Appl. No. 10/743,511
Amdt. Dated October 26, 2005
Response to Office Action of September 9, 2005

REMARKS/ARGUMENTS

FIG. 4

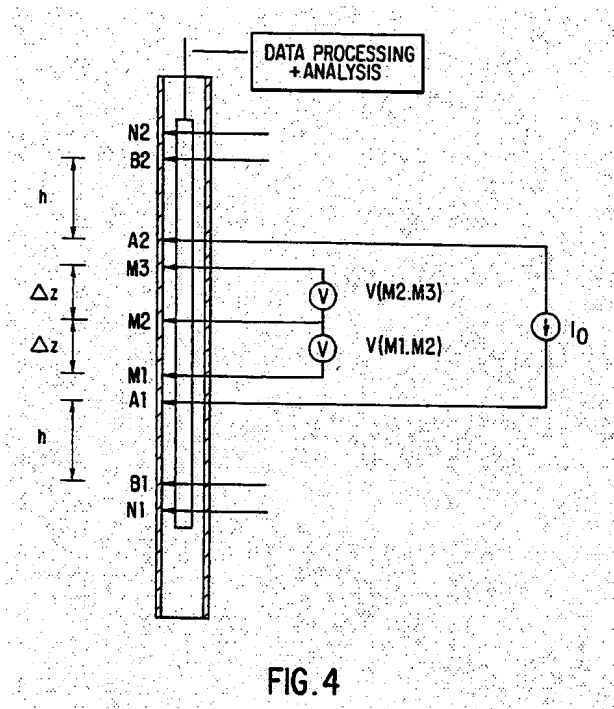
In particular, in one mode of operation current source I_0 uses electrode A1 as a current source, and electrode A2 as a current return, and the measurement electrodes are clearly between source-return pair. (Sezginer Figure 4; Col. 4, lines 5-8).

Claim 9, by contrast, specifically recites, "a first current source along said length; a first current return along said length, the first current source and first current return form a first source-return pair, wherein current from the first current source returns at the first current return; a monitor electrode along said length, the monitor electrode not between a source-return pair." Applicants respectfully submit that Sezginer does not teach or fairly suggest the limitations of claim 9. Sezginer clearly teaches the measurement electrodes to be between a current source and current return, and thus Sezginer teaches away from a system wherein "the monitor electrode not between a source-return pair."
